Yuba Community College District

New Softball Field

ADDENDUM NO. 1

Thursday, June 29, 2023

Client Project Number:	5924
Scale:	As indicated
Drawn By:	AOJ/JV/LDM
Checked By:	HC
Issue Date:	5/3/23
Revit Version:	2023
Sheet	A1.03
Sheet	5 of 58

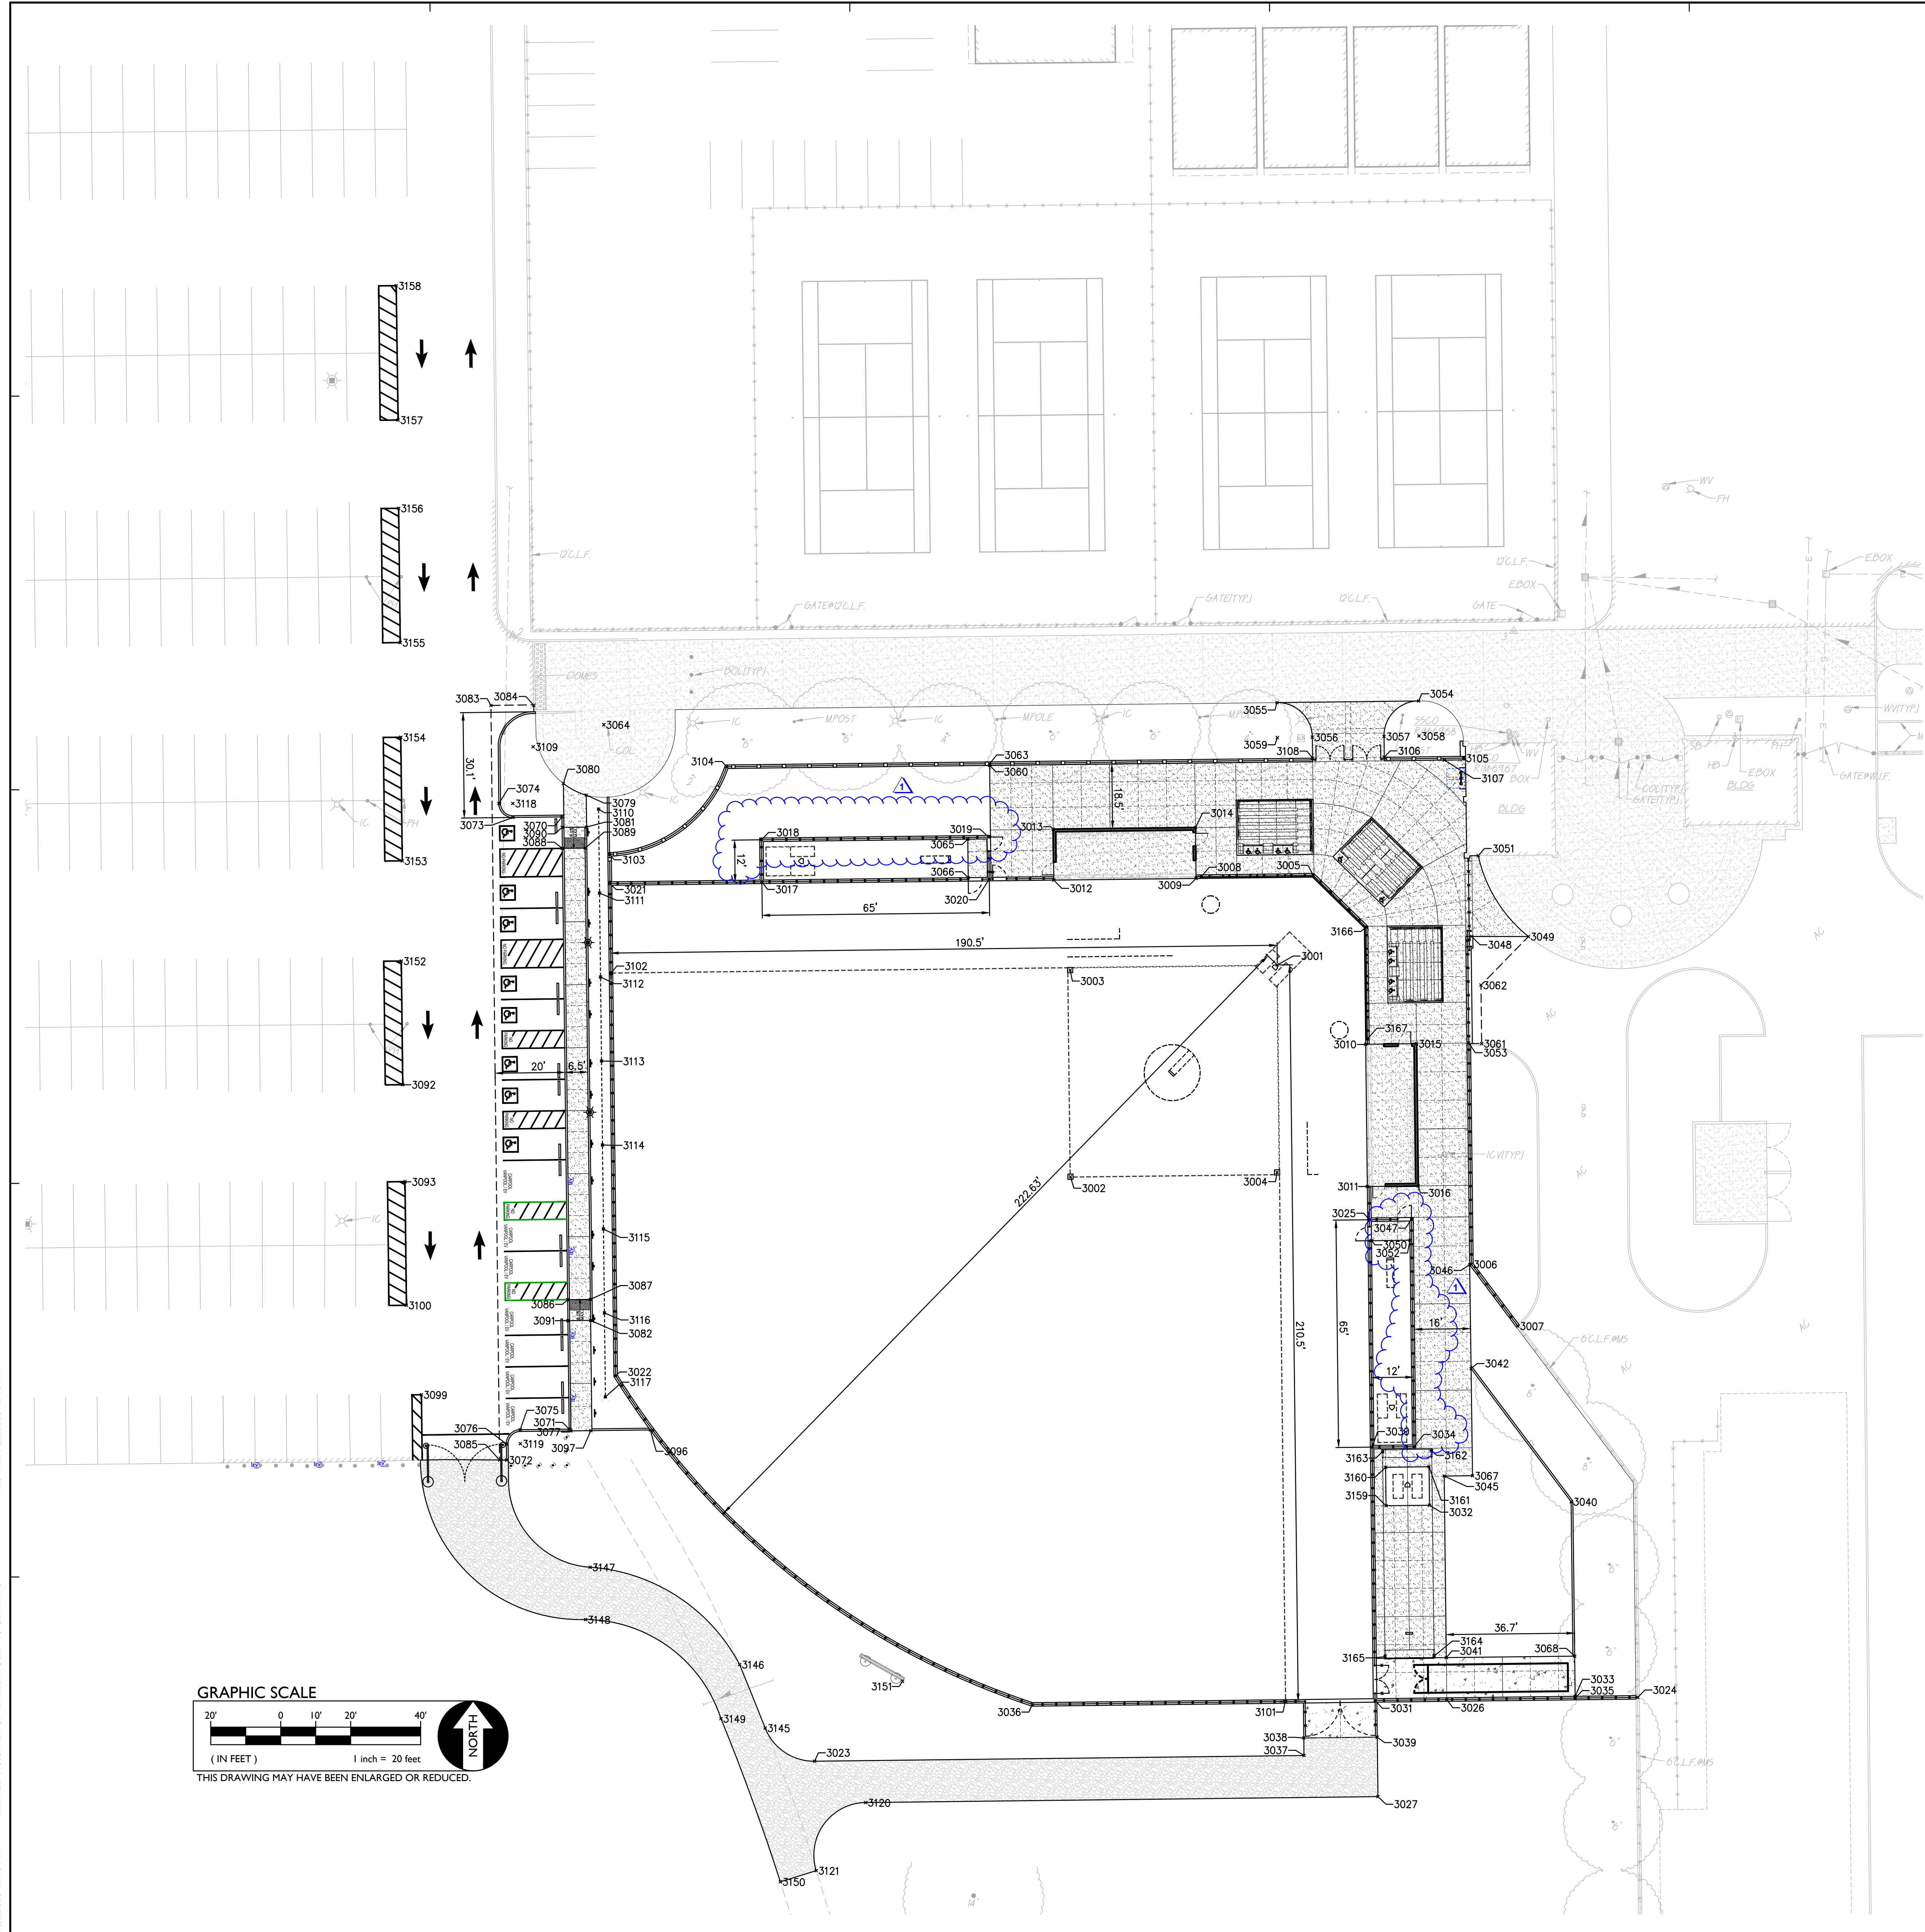
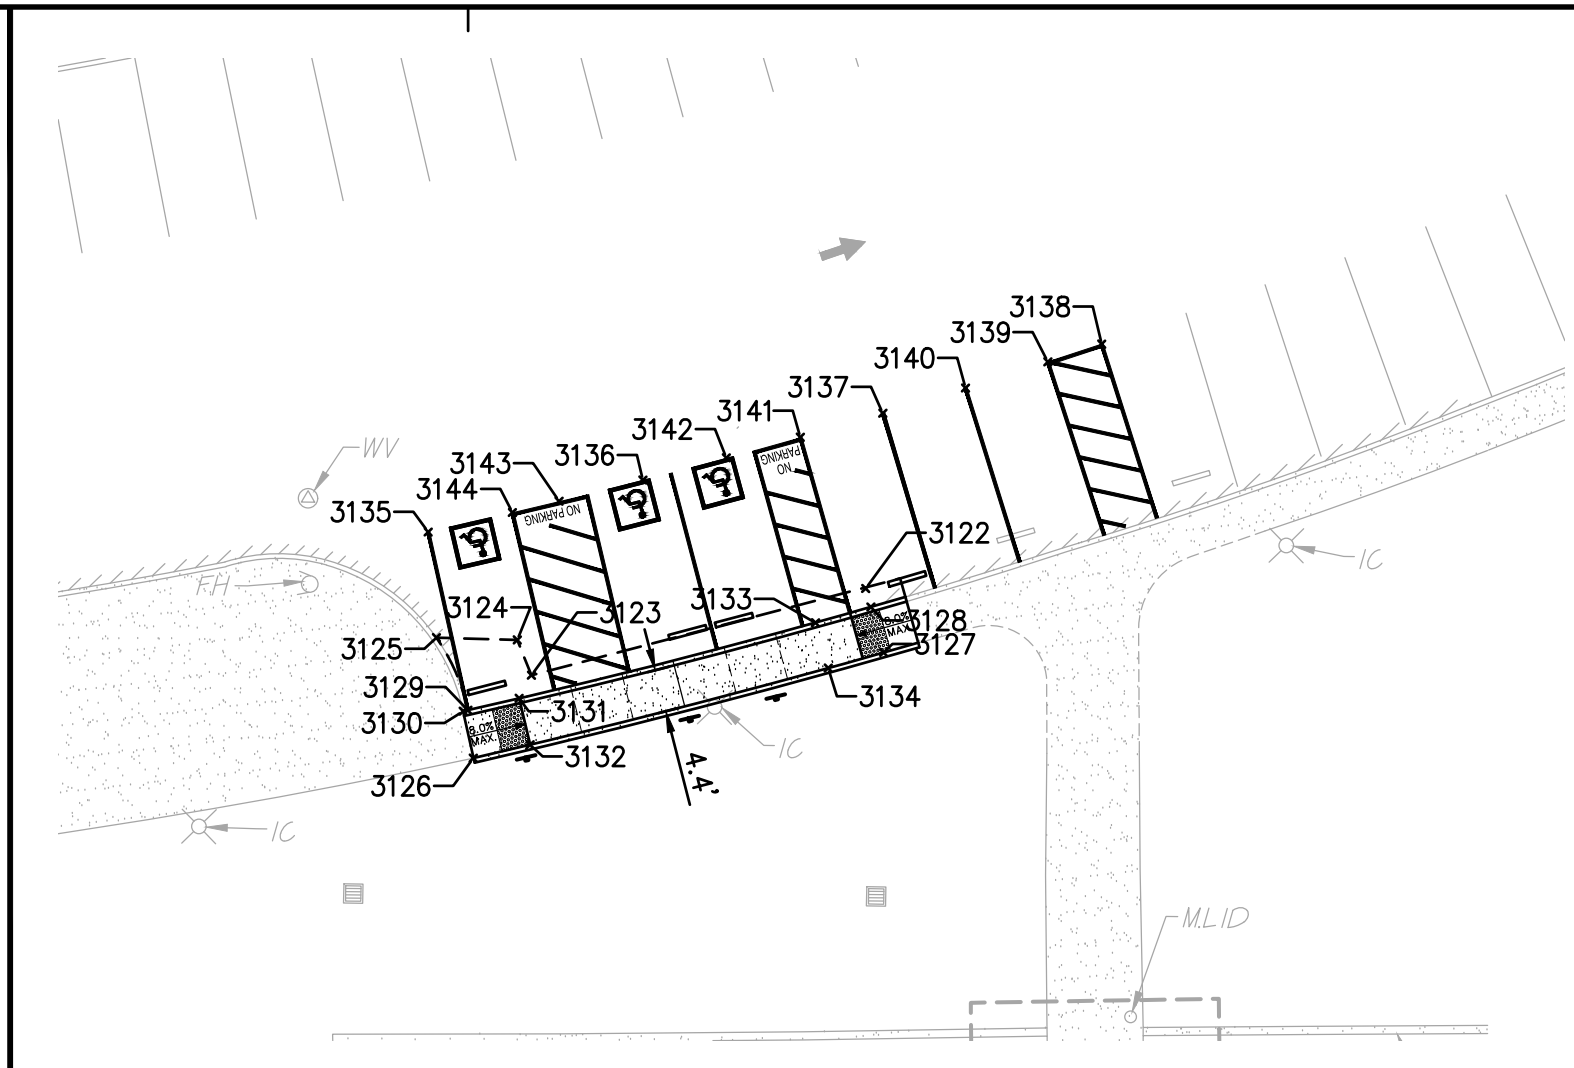
- A. **OMIT** one (1) advertising digital display screen, including associated steel framing supports and concrete footings, from scope. Digital scoreboard to remain.
- A. **REVISE** Home and Visitors bullpen from dual to single pitching lanes. Adjust grading and ground finishes per Civil drawings.

Scale:	Client Proj:
Drawn By: Author	<div style="font-size: 2em; font-weight: bold; text-align: center;">C2.2</div>
Checked By: Checker	
Issue Date: Issue Date	
Revit Version: 2023

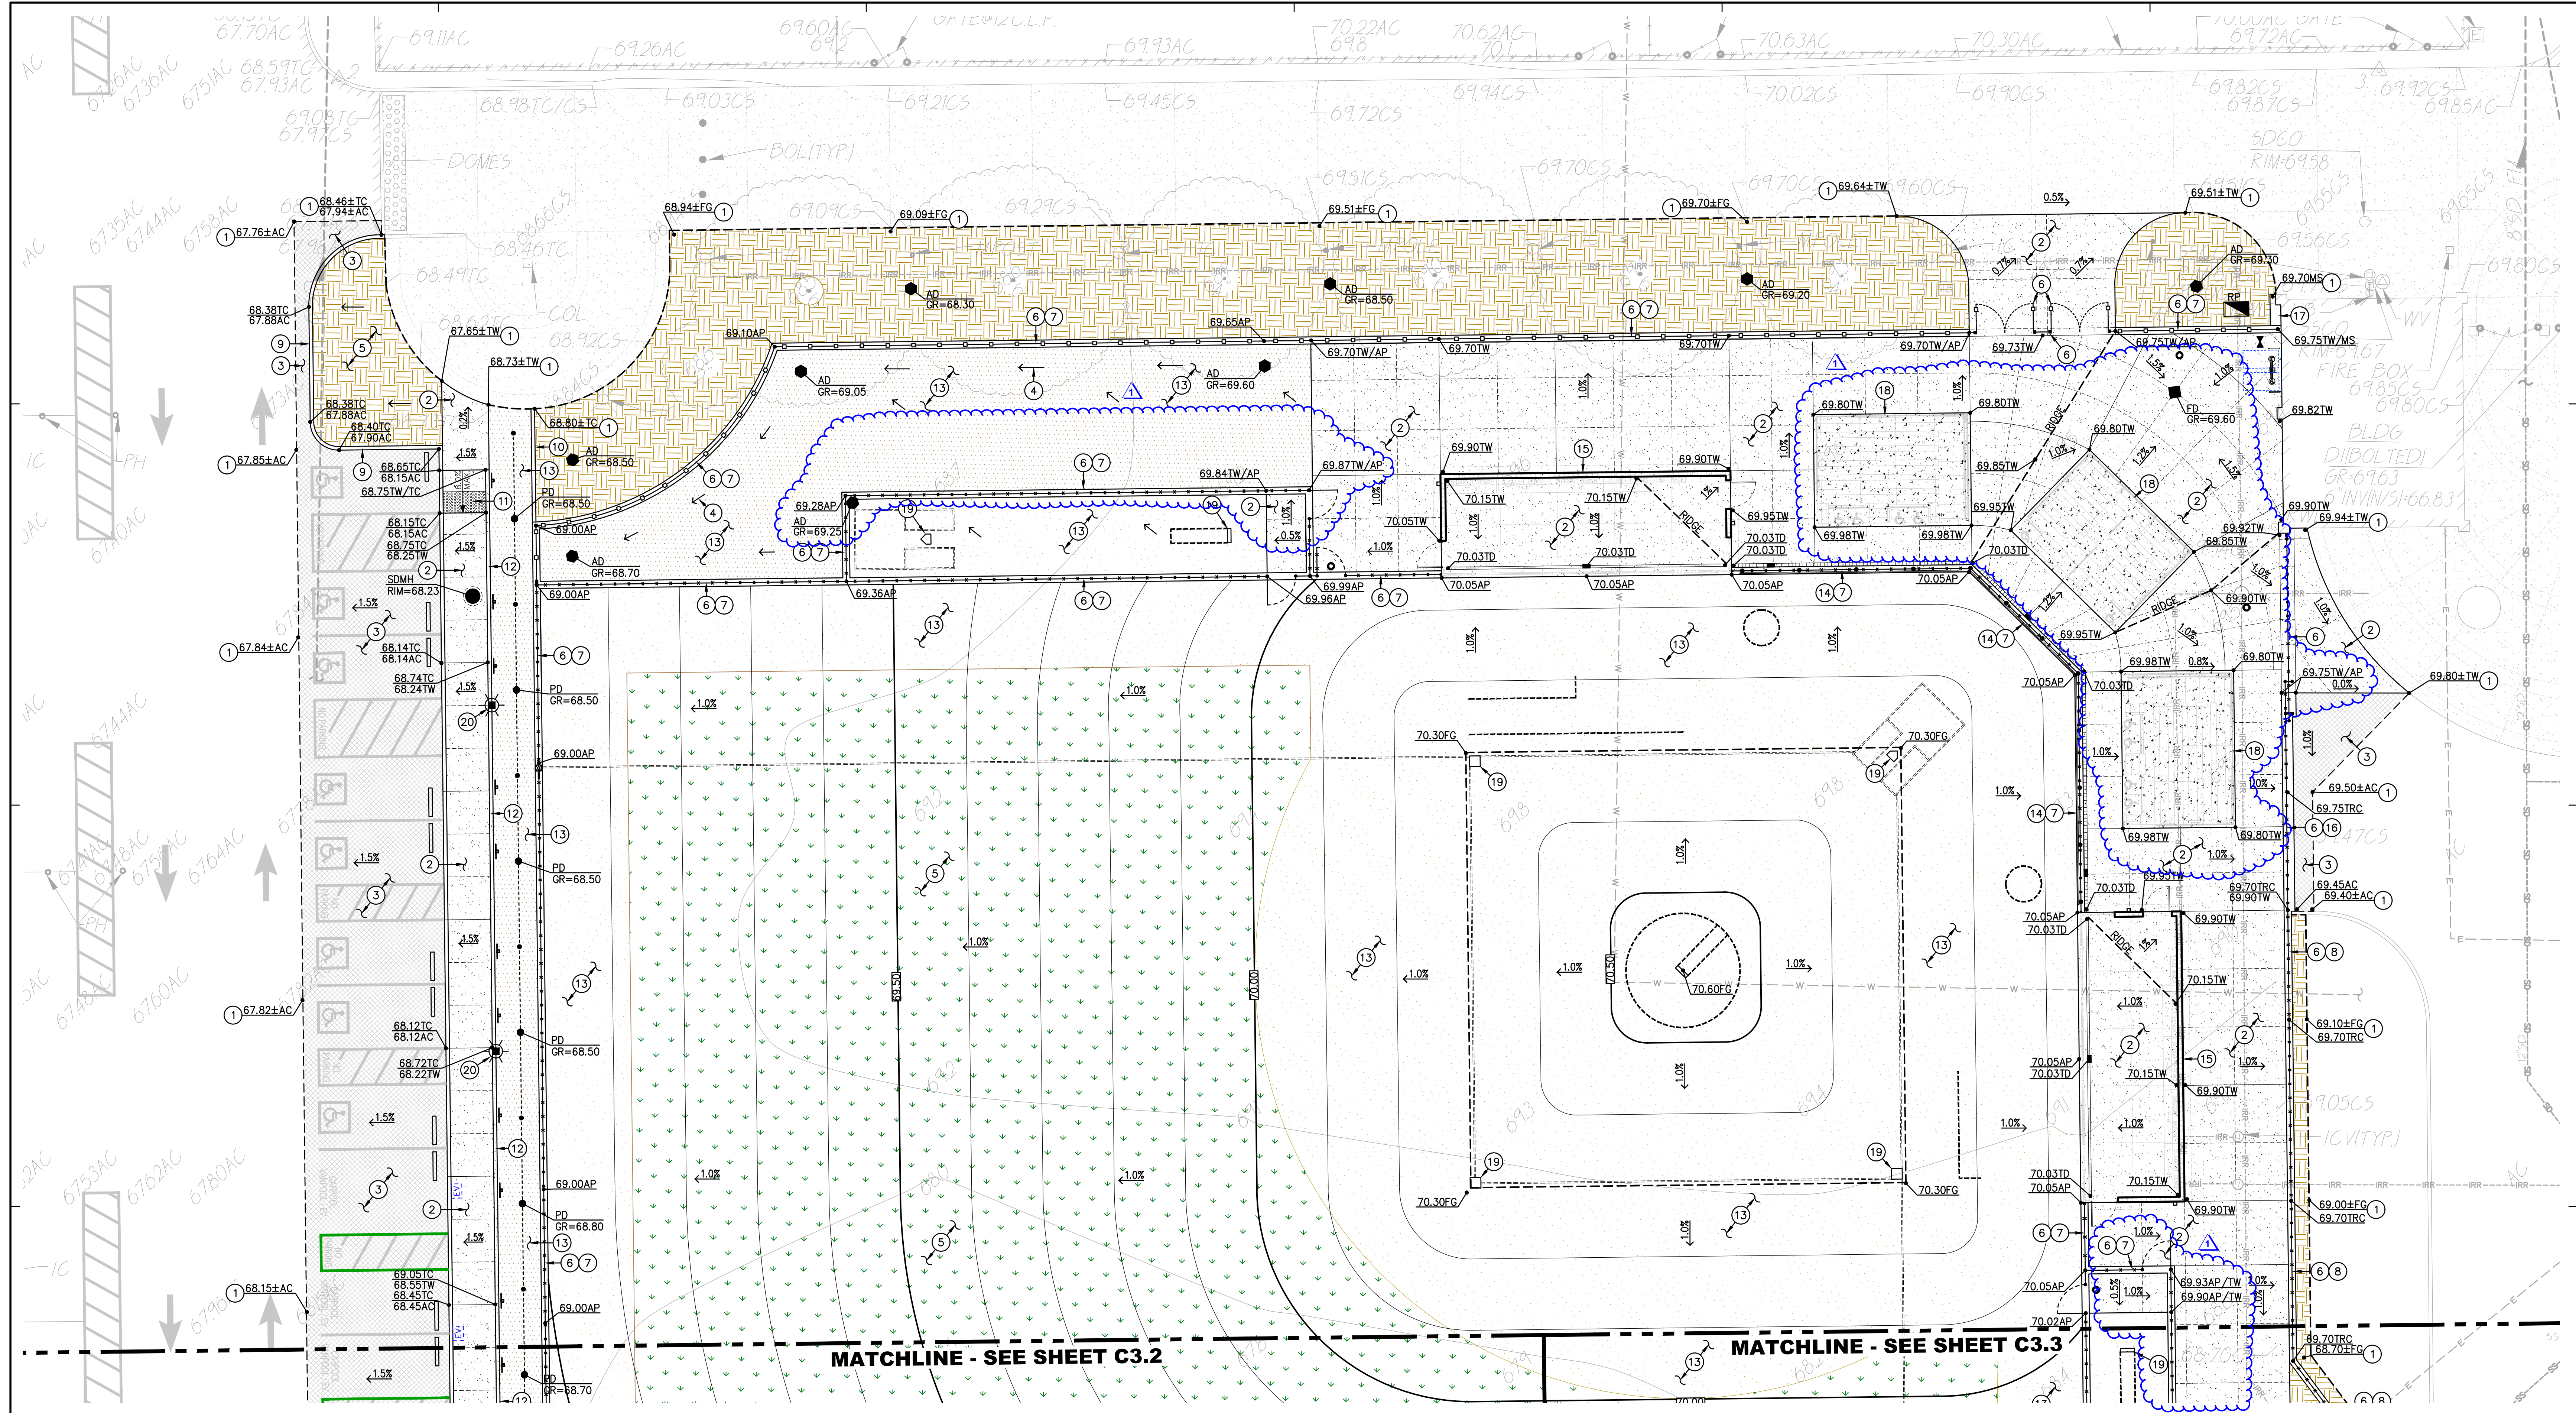
- A. **REVISE** points in coordinate list for new locations for changes on sheet C2.1.
